**RESOLUTION MSC.226(82)**

**ADOPTION OF AMENDMENTS TO THE REVISED RECOMMENDATION  
ON TESTING OF LIFE-SAVING APPLIANCES, AS AMENDED**

**Figure 4 – Stretcher dimensions (mm)**

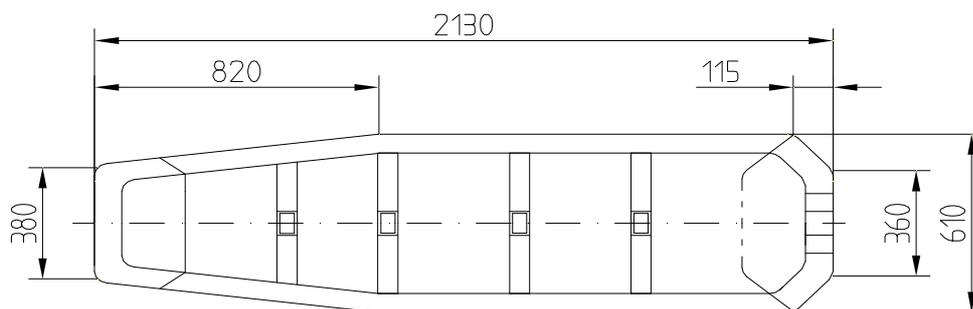
25 In paragraph 7.1.3, in the second sentence, the words “on a stretcher of similar dimensions to those shown in figure 4” are inserted between the words “lie down” and “and the others” and the following figure is inserted after the paragraph:
